**SUBJECT: Peoria County
Peoria/Janson**

SUPPLEMENT TO APPLICATION FOR PERMIT

PEORIA COUNTY
Peoria/Janson

SECTION 2-2 LOCATION OF EXISTING AND COMPLETED FILL AREAS

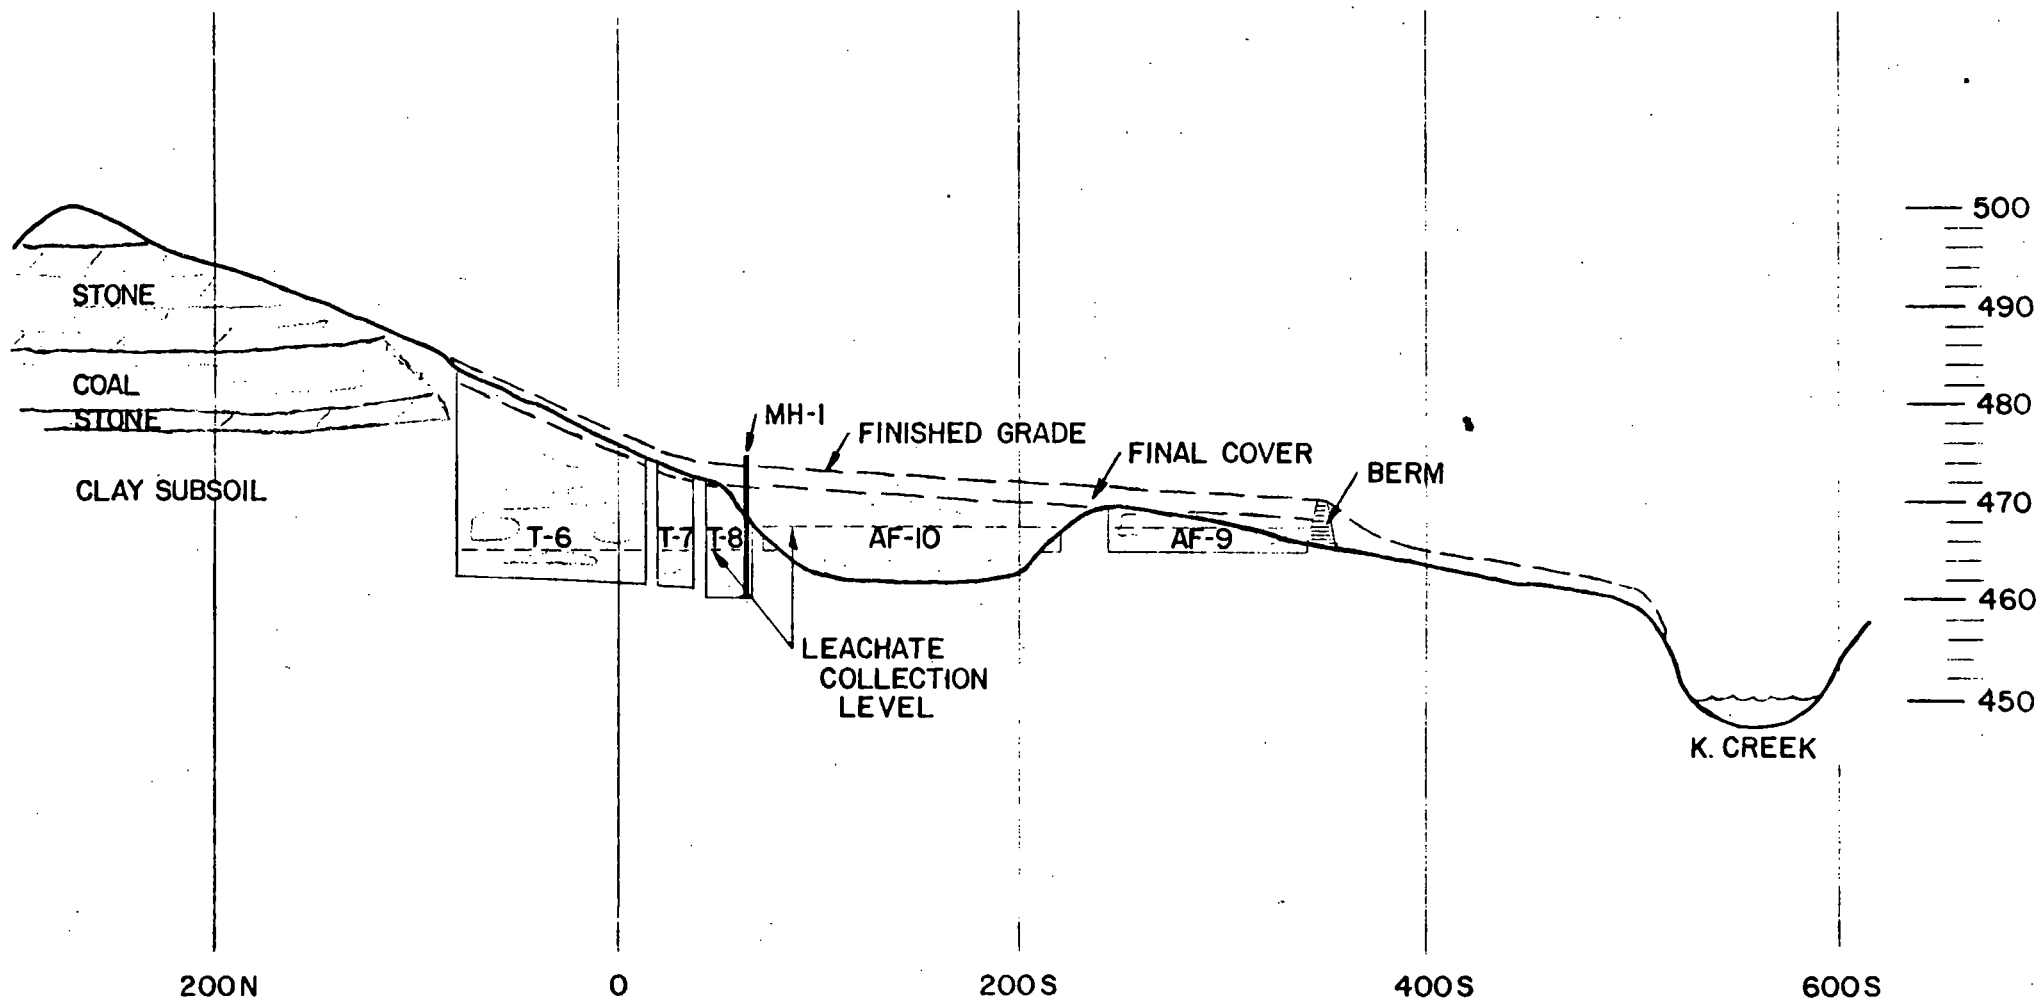
Attached is a redrawn cross-section 2 - 2 showing existing, development and completed site conditions. Cross-section 1 - 1 has not been redone since that section lies north of the major site operations and was drawn originally only to show geologic conditions in that portion of the site and adjacent areas.

TRENCH CONSTRUCTION
SCALE 1"=10'

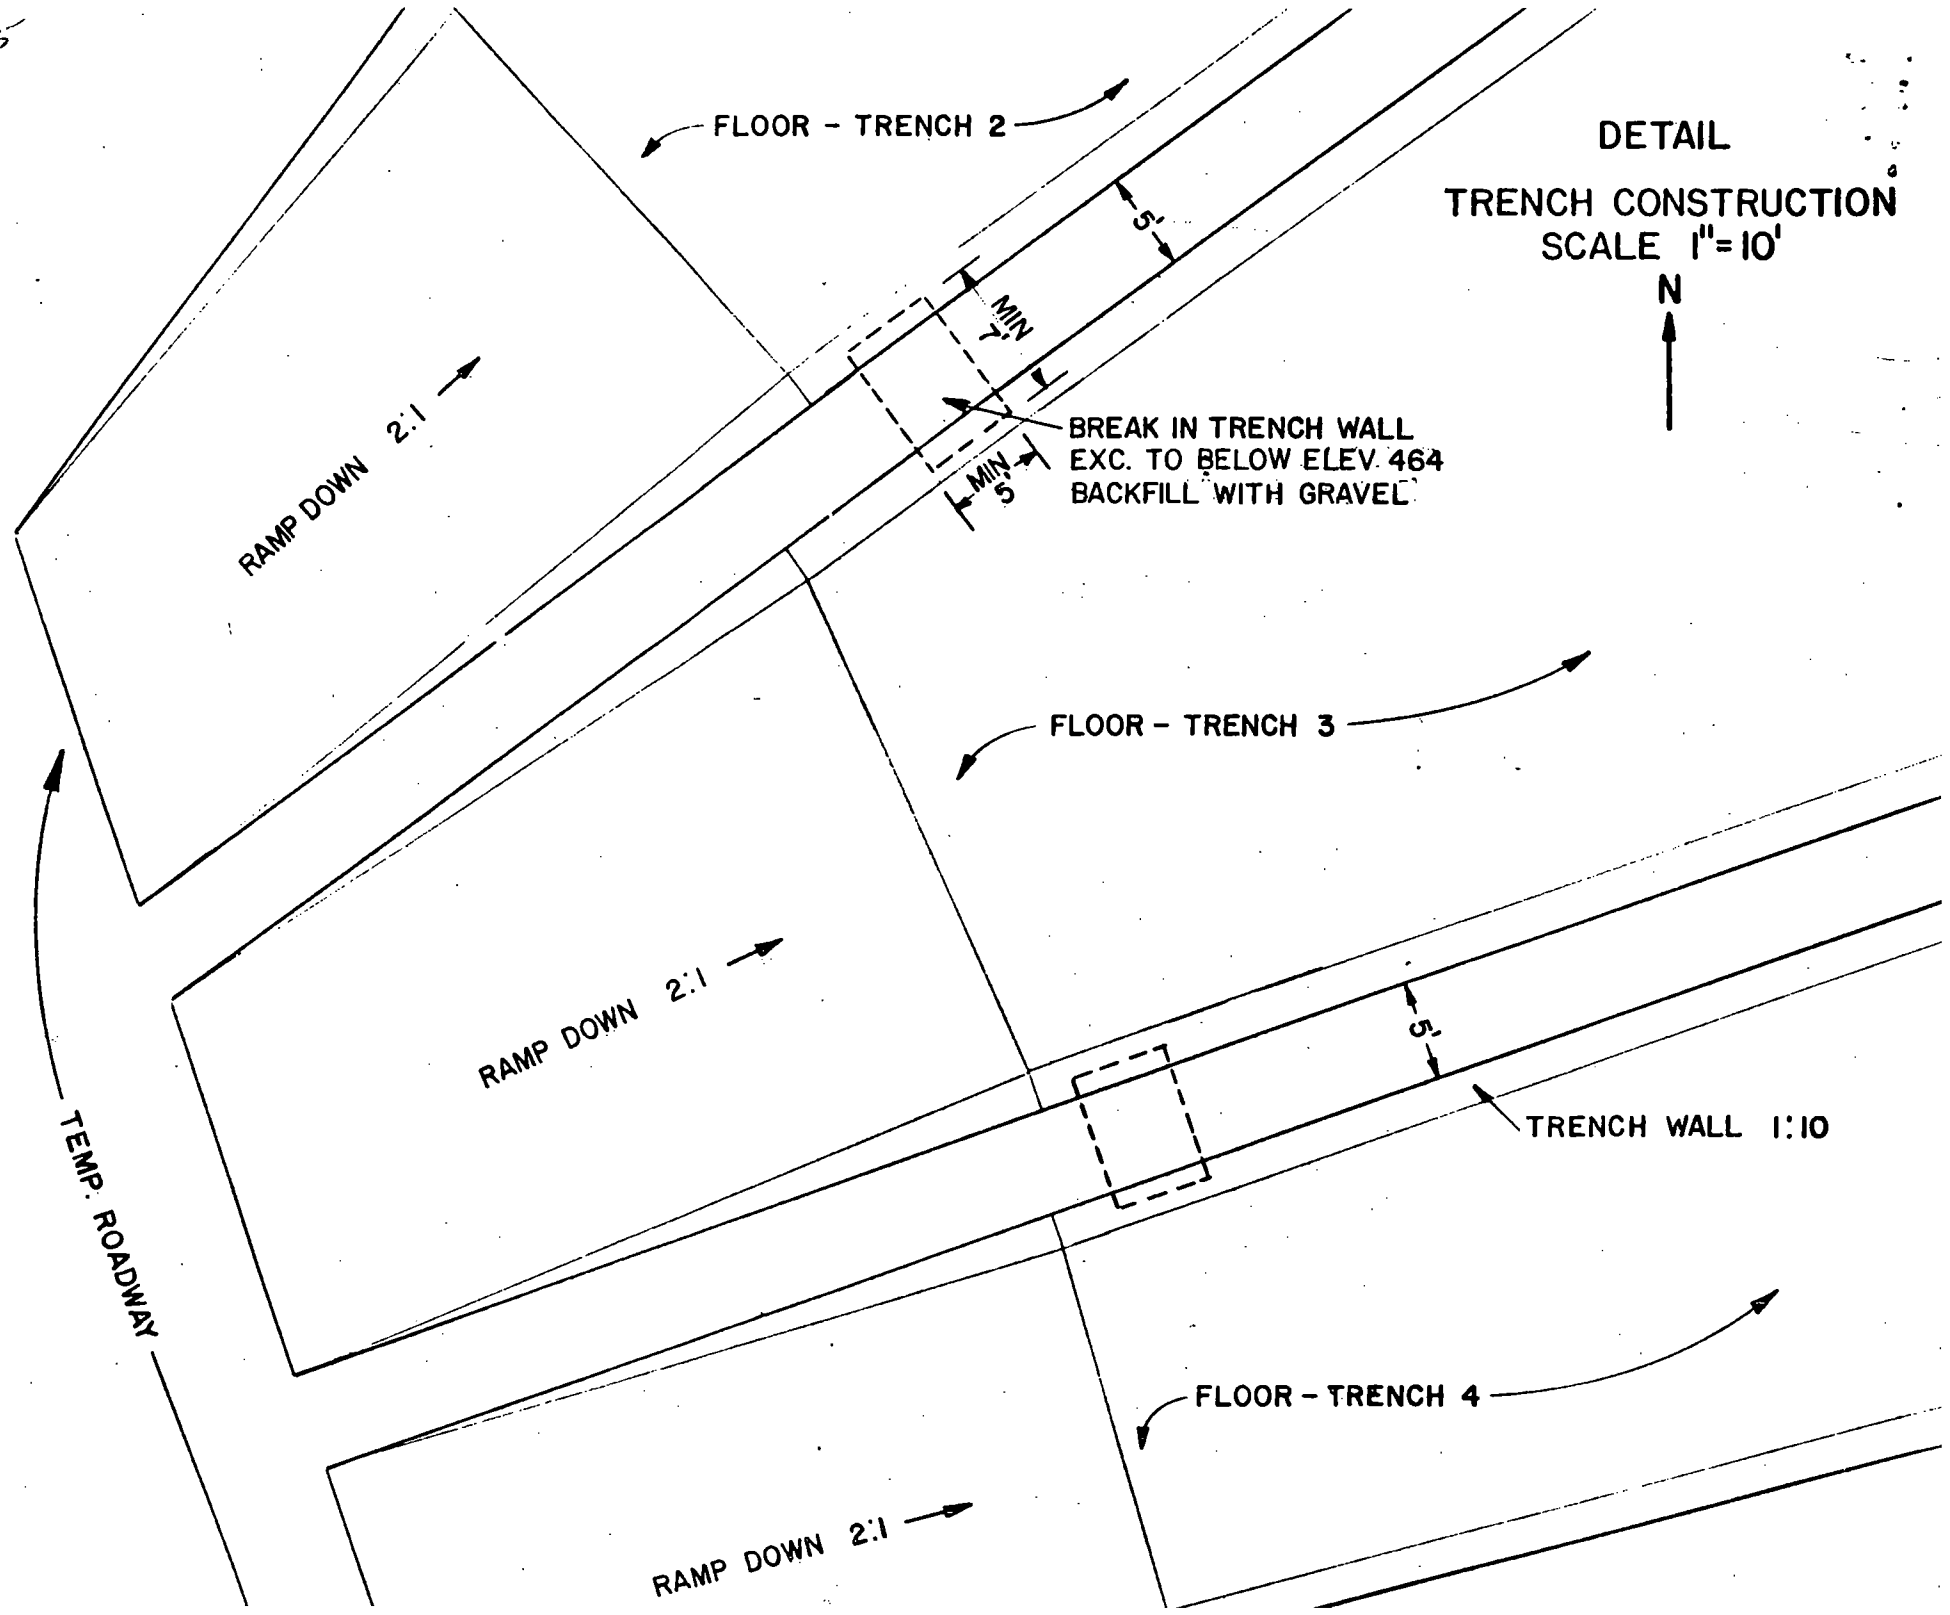
A detail of trench construction, showing the west ends of Trenches 2 through 4, is attached. The trench walls and the end opposite the entrance ramp will be constructed on a slope with a fall of one horizontal to ten vertical. The minimum trench width of twenty feet is greater than twice the width of a typical track-type dozer and will, thus, allow efficient refuse handling and covering. Since the site will be used for disposal only by the operator, this width will not present a conflict between disposal trucks and landfill equipment. The dozer will be removed from the trench while unloading takes place and can then be returned to use in the trench after the truck exits.

Inasmuch as the method of providing a break between the trenches at the floor level appears to create some operational difficulties, particularly in addressing a leachate head in a completed trench, a modified system of providing gravitational leachate flow toward the monitoring and collection system is being proposed. Following the completion of two adjacent trenches, a backhoe will be used to dig a leachate relief trench between the two trenches at the location previously proposed for the break at floor level. This relief trench will be constructed into the wall between the trenches to an elevation of 464 or below and be backfilled with one-inch gravel. This connection will then allow lateral leachate movement toward the monitoring and collection system at a level lower than that proposed for leachate collection. To aid in locating the relief trench, it's future location will be marked by a stake placed between trenches coinciding with the refuse low point. Detail is shown on the attached trench construction detail.
